# DEPARTMENT OF TOXIC SUBSTANCES CONTROL

## **Overview of DTSC's Draft Revisions to the Closure Plan**

**Thursday, September 24, 2015**

## Transportation (3.14)

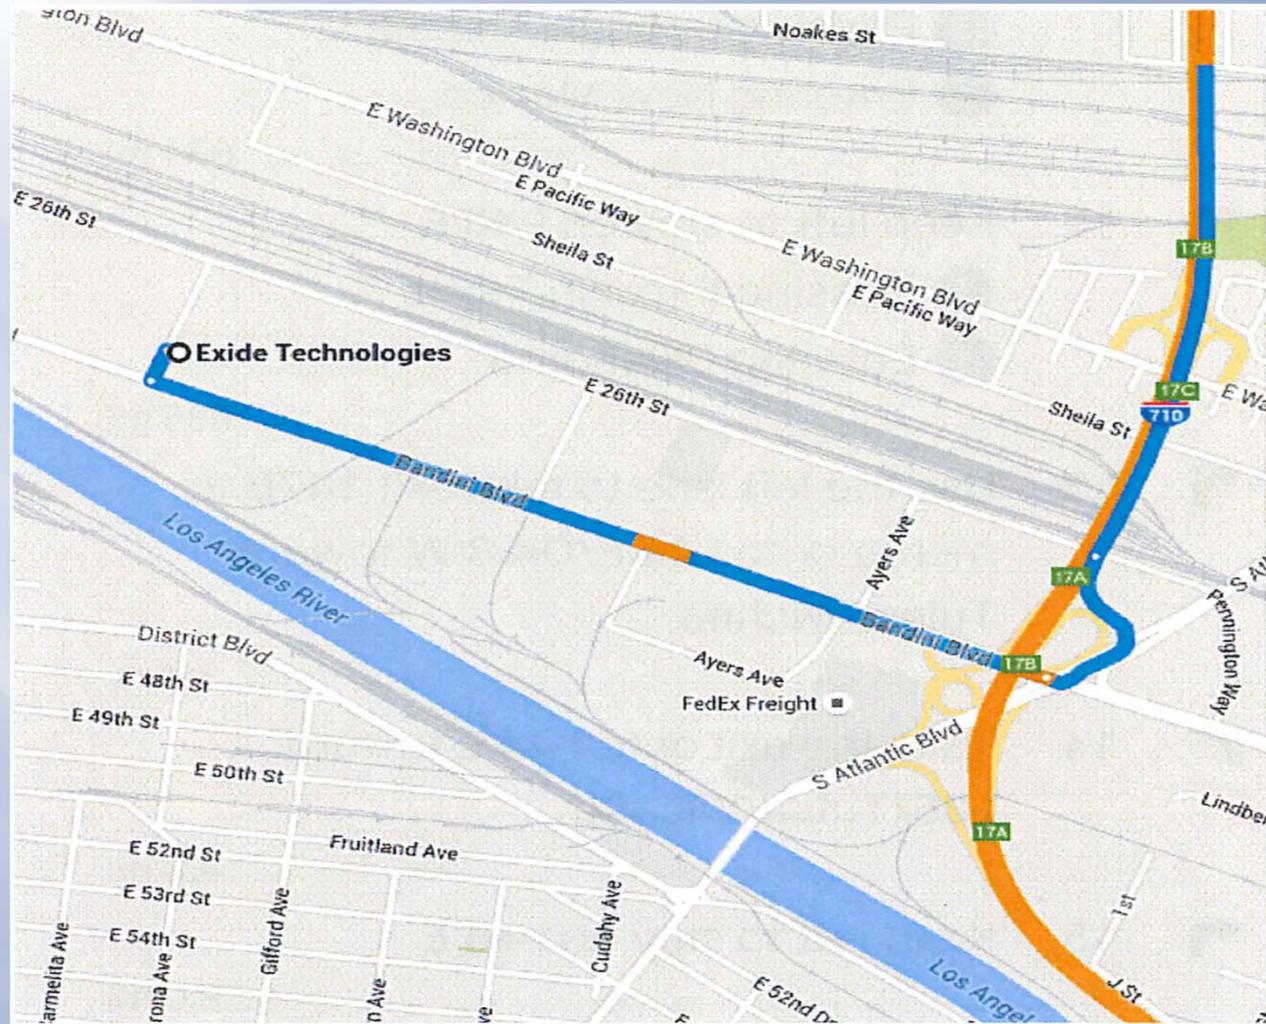
A summary of locations receiving materials during closure is provided in Table 3.4. Transportation routes are provided in Appendix Z of the Draft Closure Plan.

### ***Proposed Change to Plan:***

- All routes will proceed from the facility directly toward Bandini Boulevard, turn left onto Bandini Boulevard and merge onto I-710. Directions to 2801 N Madera Road will be revised to proceed to I-710 using this route.
- Any change from the Bandini to I-710 portion of routes will require DTSC pre-approval.
